DRAINAGE REPORT
for
ASPEN WILLOW ESTATES
EL PASO COUNTY, COLORADO

2N Civil Project No. 25011

Date: March 30, 2026

V1_Drainage Report - Final.pdf Markup Summary

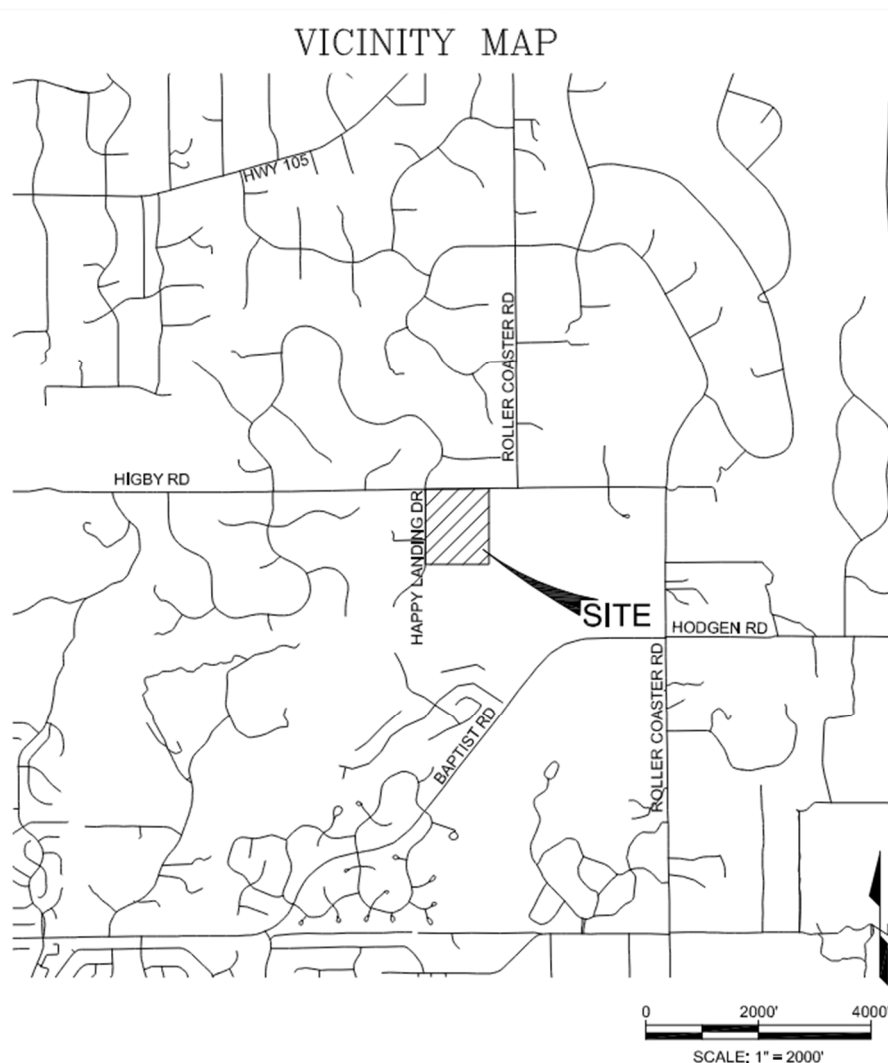
Replace this with, see below:
Reminder Execute the new page.

EXISTING DRAINAGE BASINS
ASPEN WILLOW ESTATES
EL PASO COUNTY, COLORADO

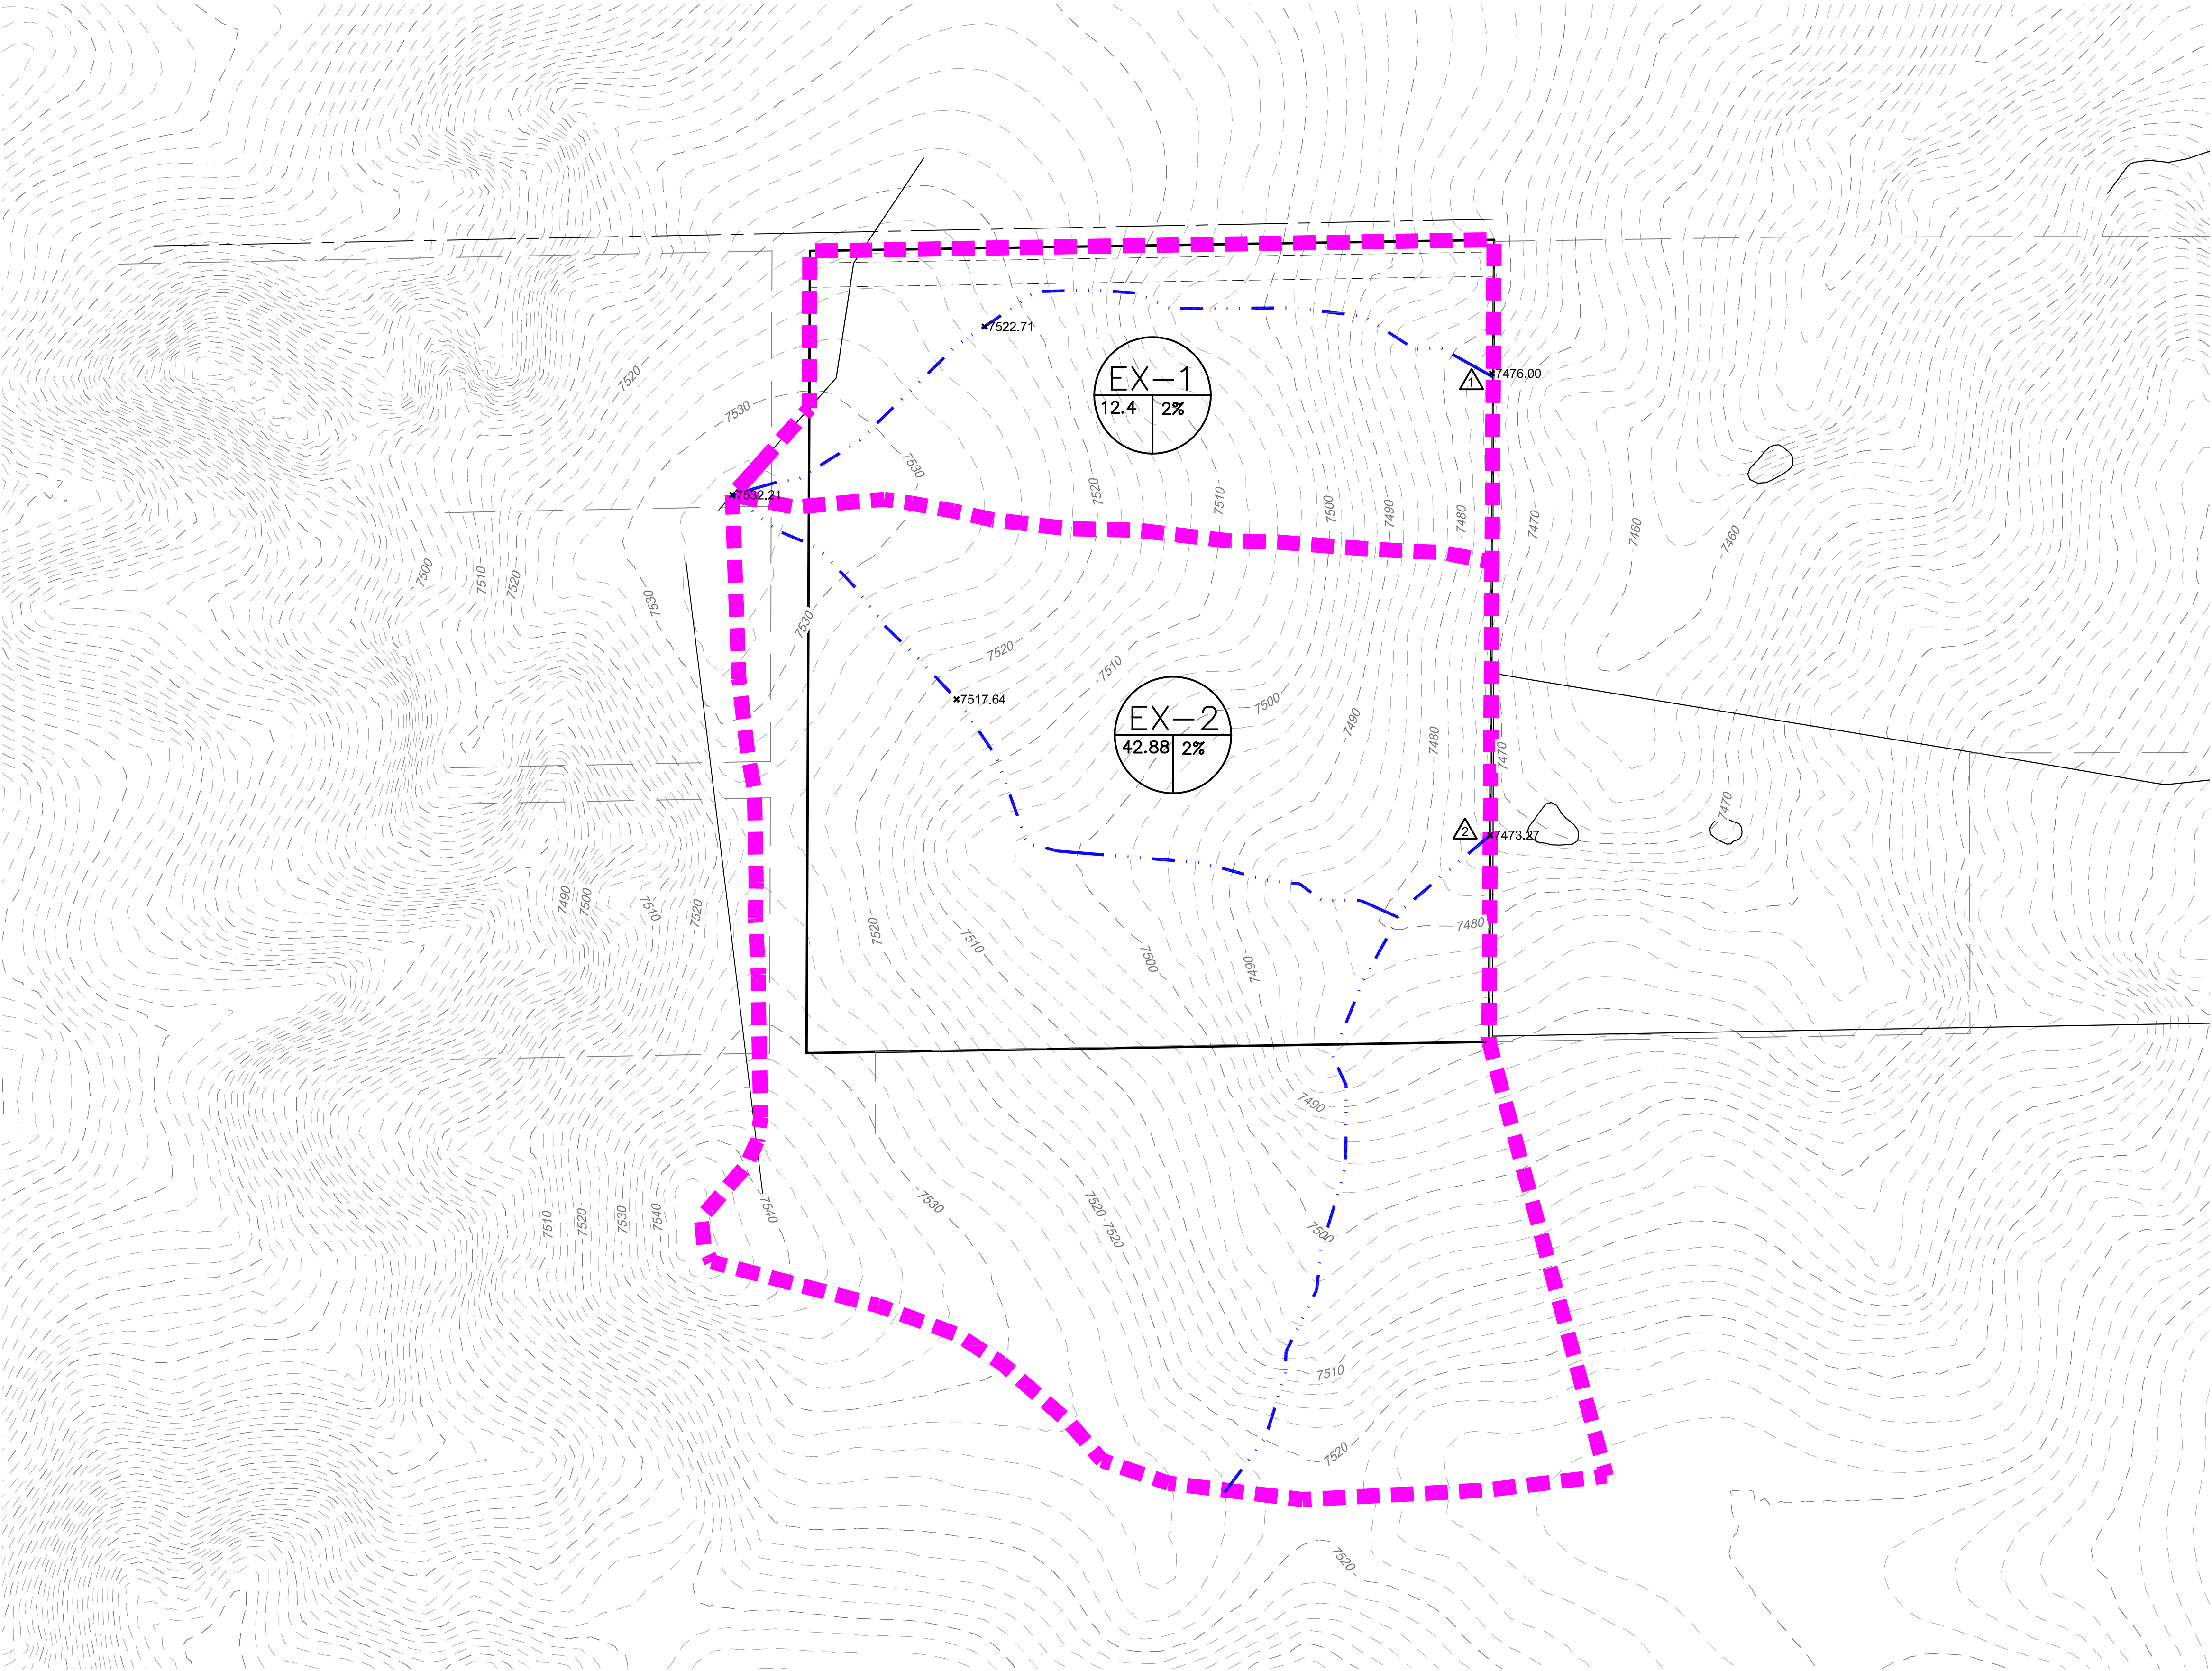
It appears that your current disturbance will be slightly over 1 acre. With this design a Stormwater Permit (ESQCP) will be required. If the design can be revised to reduce the disturbed area (limits of disturbance) to less than 1 acre, a permit will no longer be required.

Note: We still recommend acquiring a stormwater permit if disturbance is just short of 1 acre (like 0.95-0.99) as it will help protect the site from receiving an "operating without permit" Stop Work Order (SWO) if the limits of disturbance are expanded during construction. If the LOD changes and you already have a permit then you only need to redline the new LOD on the GEC plan. Without a permit construction would have to stop until disturbance is returned to <1 ac or a permit is acquired.

Verify if you need a culvert here, if yes, provide the design per EPC standards and specifications and make sure to keep the culvert in the ROW.

Portion of the proposed pipe and outlet are outside the proposed ROW. Show and label the proposed drainage easement and provide the reception number etc.
